**Department of Energy
Office of Legacy Management**

Subject: Ground water evaluative monitoring plan at the Shirley Basin South, WY, Disposal Site

Shirley Basin South Disposal Site
POC Wells
Uranium Concentration
ACL = 9.2 mg/L

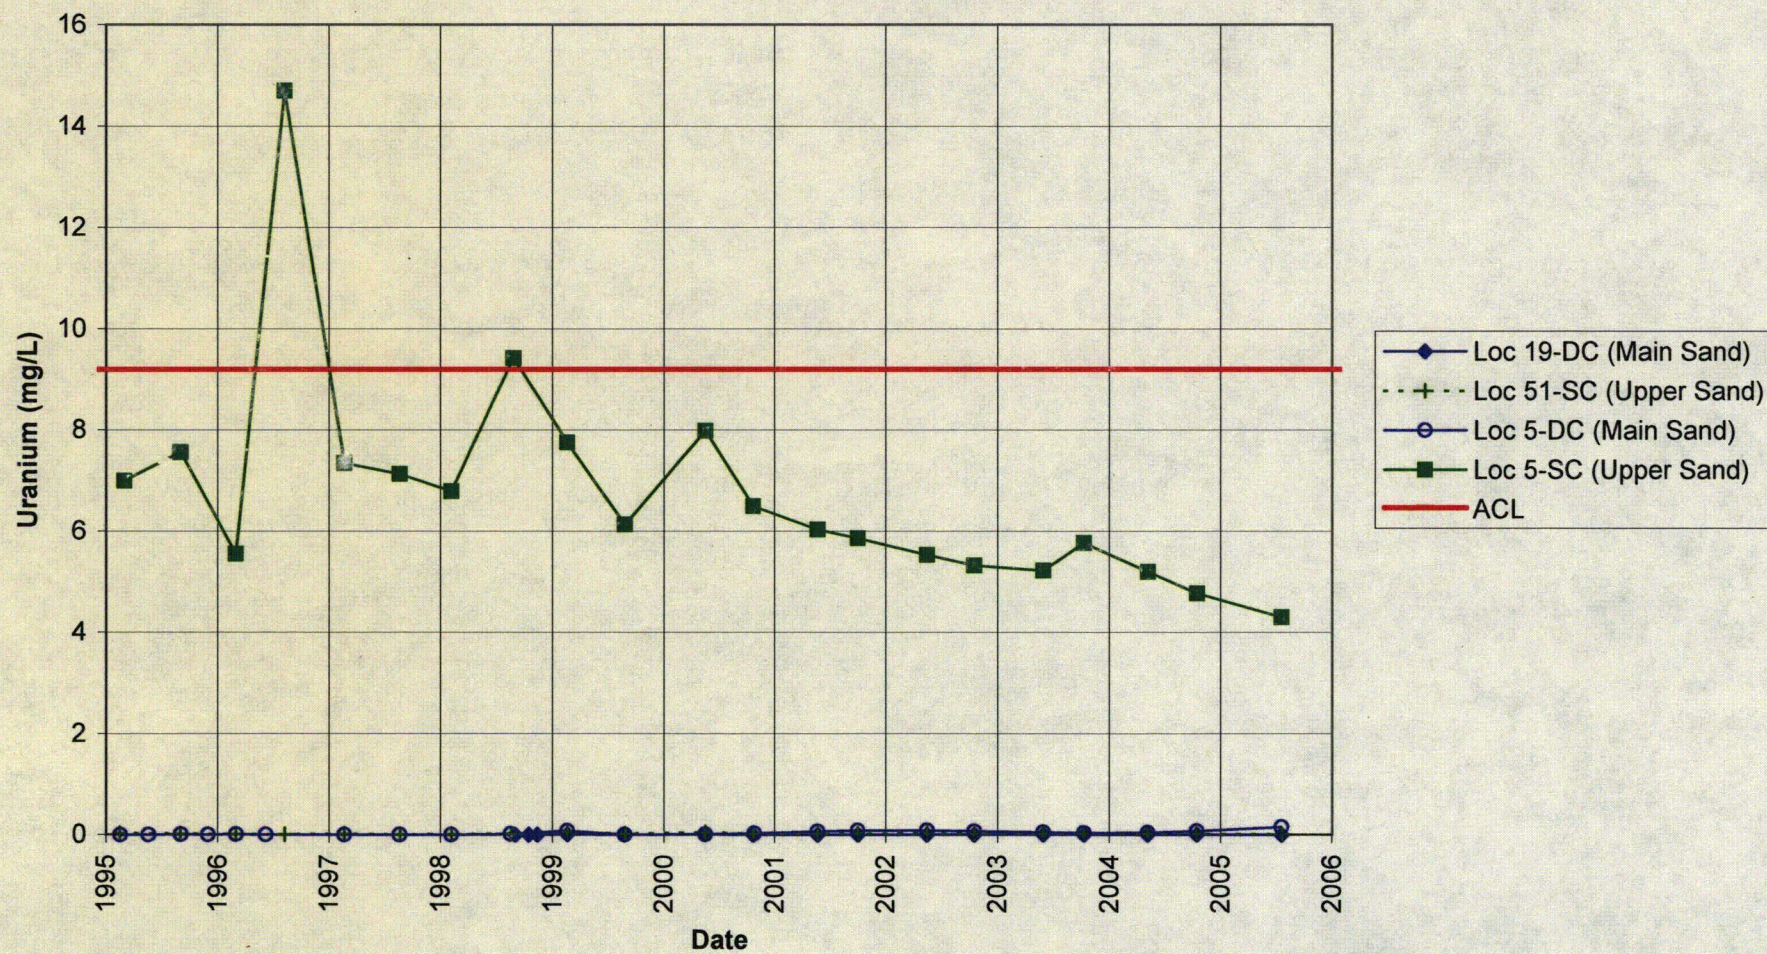
Uranium and sulfate are the primary plume indicator contaminants for the aquifers. As shown on the enclosed charts, uranium and sulfate in the POC wells are indicating downward trends in the Upper Sand aquifer, and lower and steady concentrations in the Main Sand aquifer. At this time, therefore, DOE does not anticipate a threat to human health or the environment from the contaminant plume at the site. Moreover, DOE will not allow use of ground water from the Upper Sand and Main Sand aquifers at the site for any purposes.

Shirley Basin South Disposal Site
Non-POC Well 54-SC
Radium-228 Concentration
(ACL not applicable)

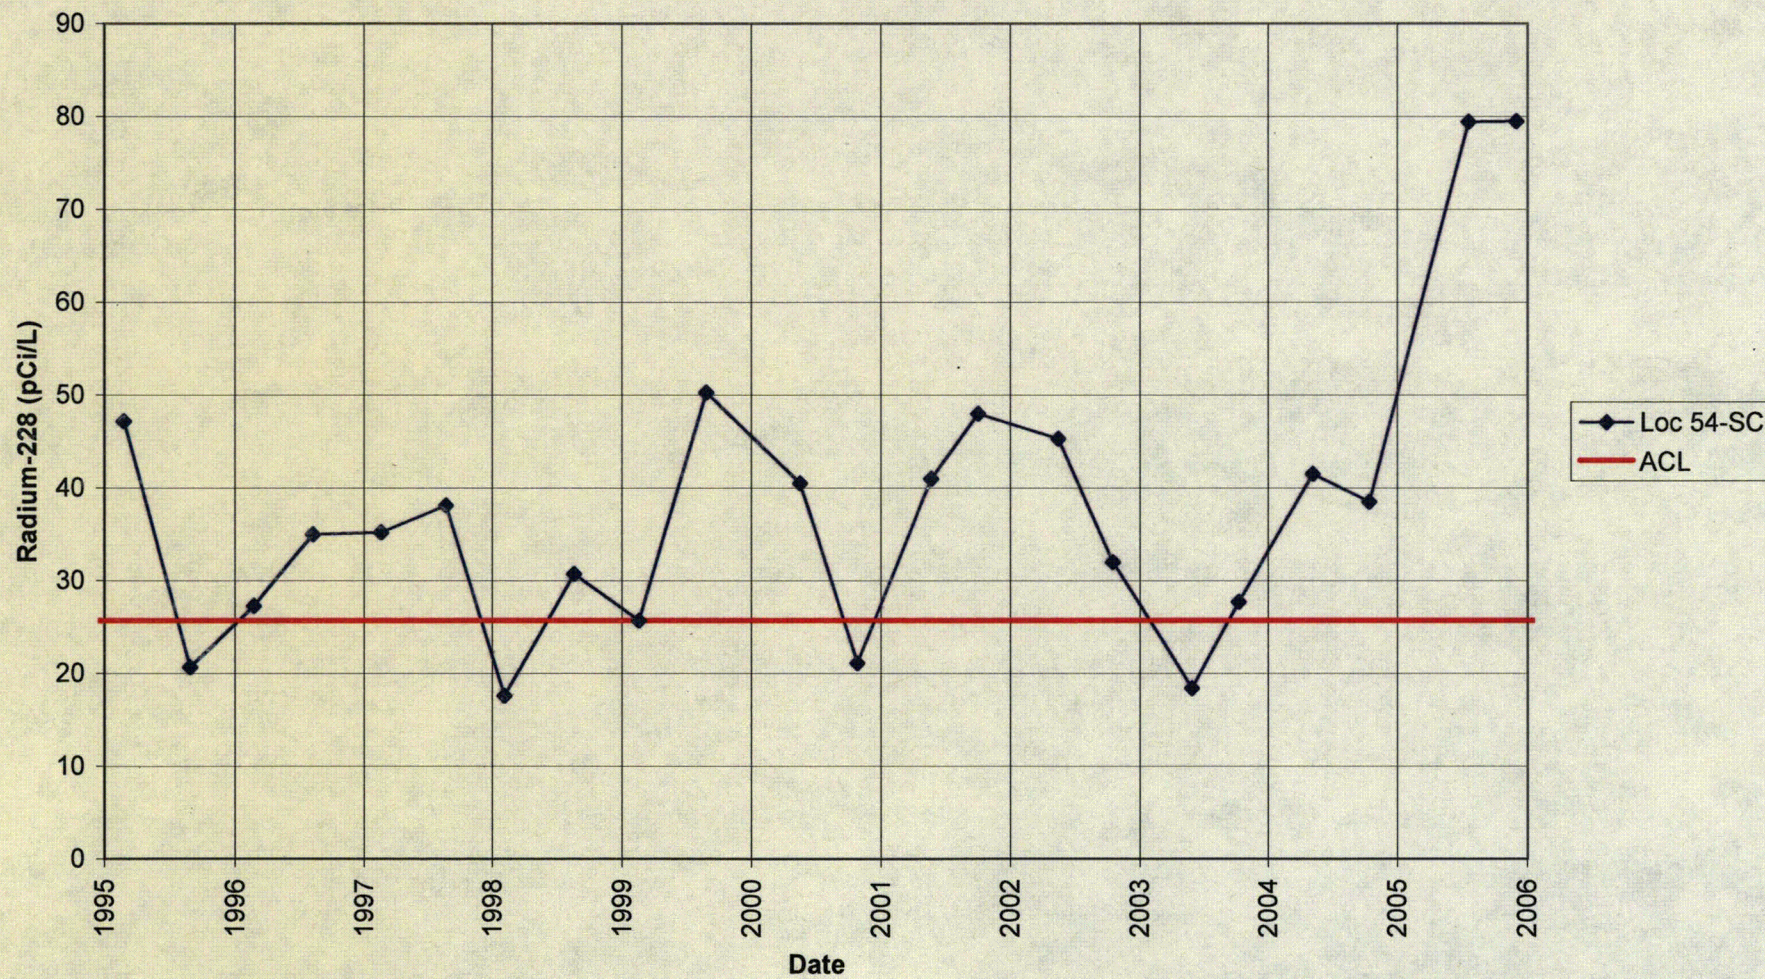
The radium-228 result for Well 54-SC was not reported to the NRC because it is not a designated POC well in the LTSP and, therefore, ALCs do not apply to this well. However, the well was resampled by DOE in December 2005 and the radium-228 result was the same as the July result. As shown on the enclosed chart, radium-228 in this non-POC well has consistently exceeded the ACL designated for the POC wells.

Well 54-SC is a downgradient well with respect to the disposal cell, but it cannot be compared to Well 5-DC to track the potential migration of radium-228. Well 54-SC is completed in the Upper Sand aquifer of the Wind River Formation, whereas Well 5-DC is completed in the underlying Main Sand aquifer of the same formation. Well 54-SC is downgradient of Well 5-SC, so the potential migration of cadmium will be monitored.
